Invitation of Public Comments

Sub:- Balance work of four laning of Haridwar- Dehradun section (Pkg-II) From Laltappar (Design Ch.181.100) to Mohakampur (Design Ch.158.900) of NH-72 on Item Rate Basis.

S.H:- Permission sought by M/s Uttarakhand Urban Sector Development Agency for laying of 9"dia HDPE sewer pipeline from Km.158+900 (Mohakampur) to Km.161+719 (Nakronda Police Chauki) section of NH-72 (New NH-7) for total length of 3285.4m in Dehradun District in the State of Uttarakhand-reg.

Sub:- Proposal of M/s Uttarakhand Urban Sector Development Agency for laying of 225mm dia sewer Pipeline in b/w Ch.158+900 to Ch. 161+719 of NH-72 (New NH-07)-reg.

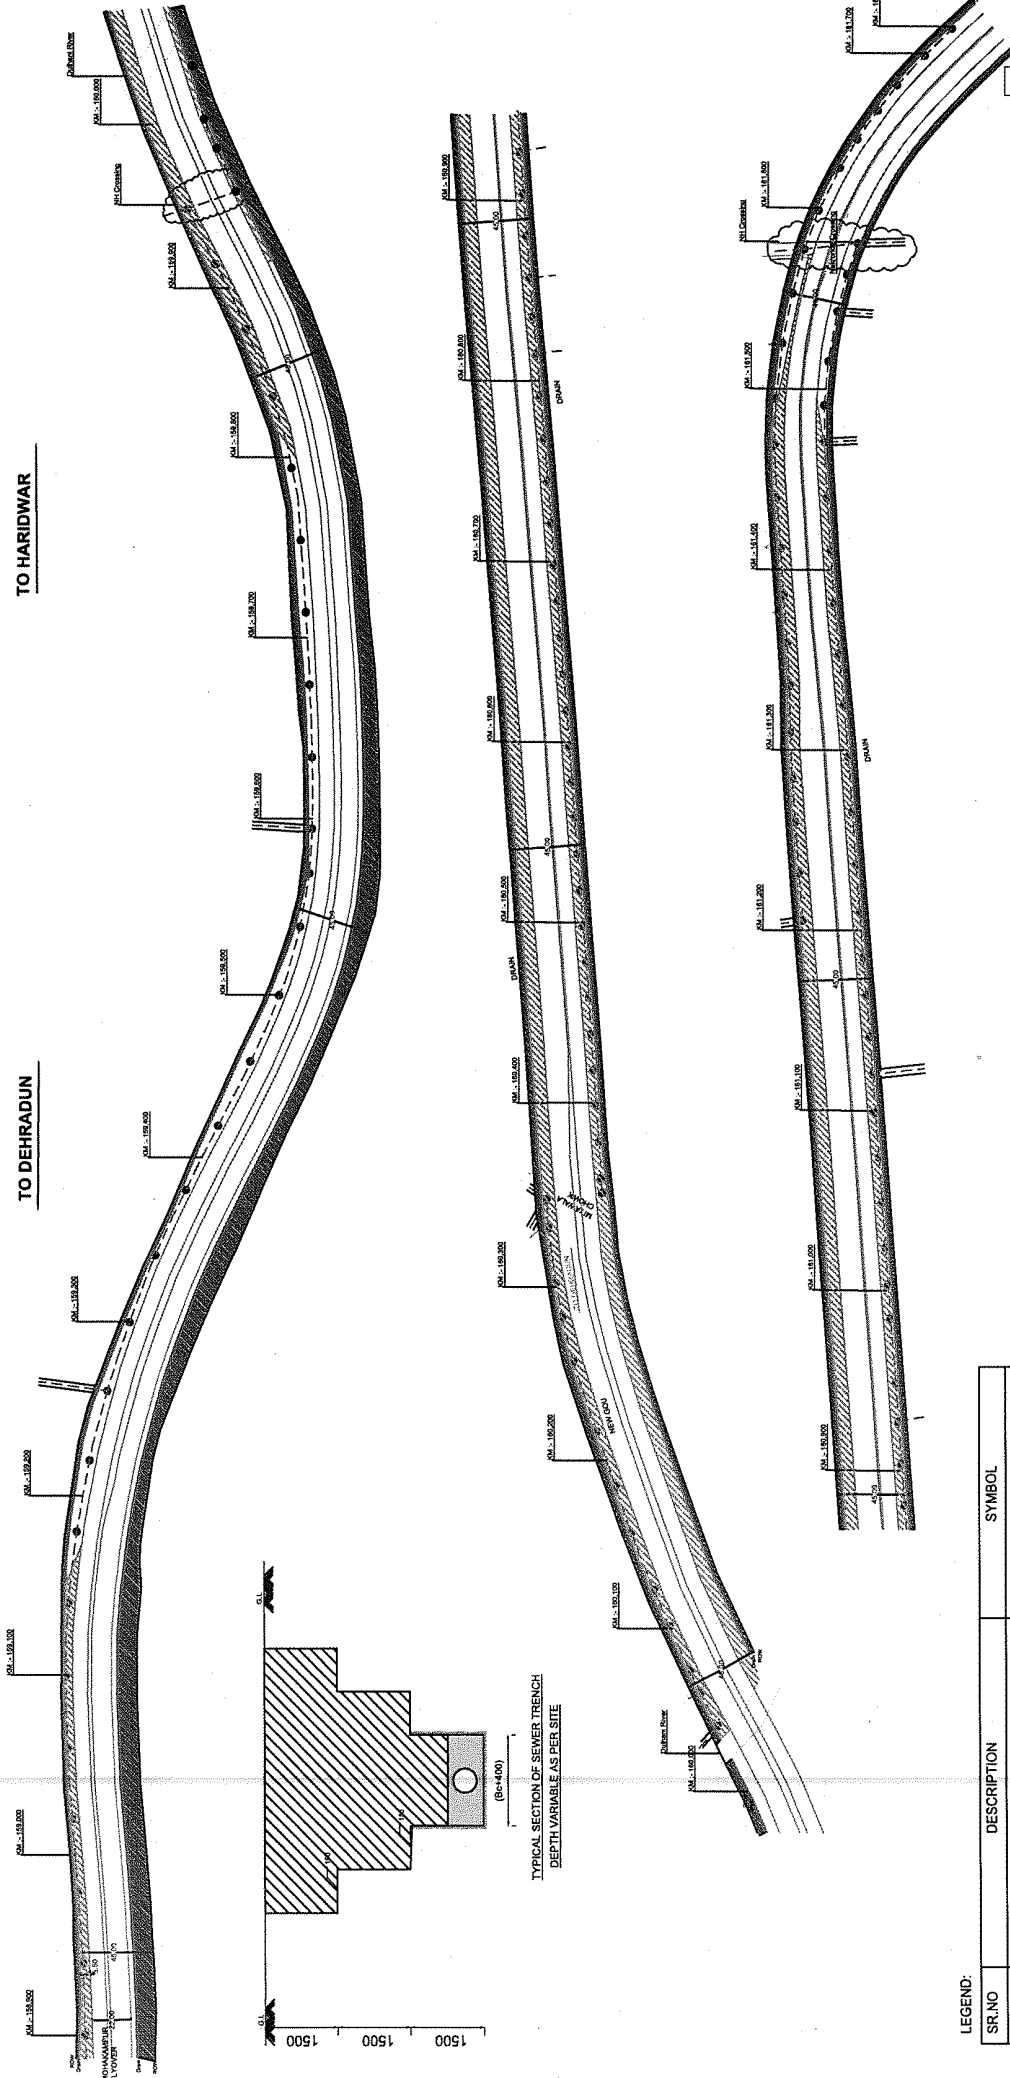
- (ii) Checklist, drawings i/c layout plan, manhole plan & section, cross sections need to be signed duly verifying the details, documents, data etc. mentioned in the checklist.
- (iii) Calculation for license fee & performance security furnished by utility agency to be verified in line with guidelines & the calculations also need to be signed. It may also be ensured that base slab outer dia that is effectively covered/utilized the NH land will be used for calculation.
- (iv) An Inspection report reviewing/examining the prevailing site conditions to assess the suitability of submitted proposal of user agency along with proposed methodology w.r.t extant Ministry guidelines.

- Checklist, drawings i/c layout plan, manhole plan & section, cross sections needs to be signed duly verifying the details, documents, data etc mentioned in the checklist.
- Calculation for license fee & performance security furnished by utility agency to be verified in line with guidelines & the calculations also need to be signed. It may also be ensured that base slab outer dia that is effectively covered/utilized the NH land will be used for calculation.
- An inspection report reviewing/examining the prevailing site conditions to assess the suitability of submitted proposal of user agency along with proposed methodology w.r.t extant Ministry guidelines.

- i. All drawings, documents, mentioned in check list are uploaded on portal and herewith are enclosed with proposal.
- ii. In this regards, Calculation of License fees & performance security has been revised with considering outer dia of manhole. The revised License fees is Rs.30,18,198.00 (Rupees Thirty Lakh Eighteen Thousand One Hundred & Ninty-Eight only), the same is herewith enclosed with proposal.
- iii. The site inspection report with proposed methodology is enclosed with proposal.

S. no	Observations	Compliance
1.	Check list, drawing i/c layout plan, manhole plan, section and all related documents needs to be signed duly verifying the details, mentioned in checklist	All drawings, documents, mentioned in check list are uploaded on portal and herewith attached for your kind information and taking necessary action, please.
2	Calculation of License fees & performance security furnished with considering outer dia of manhole slab.	In this regards, Calculation of License fees & performance security has been revised with considering outer dia of manhole. The revised License fees is Rs. 30,18,198.00, also rate calculation is herewith attached for your kind information and taking necessary action, please.
3	Regarding proposed methodology of sewer line laying	Laying of Sewer pipe line (material HDPE/DI/MS Pipeline) along NH-72 will be laid by open cut conventional method/manual and by manual jack pushing/HDD (Trench less method) in NH crossing. The detail of methodology of sewer laying is herewith attached for your kind information and taking necessary action, please.
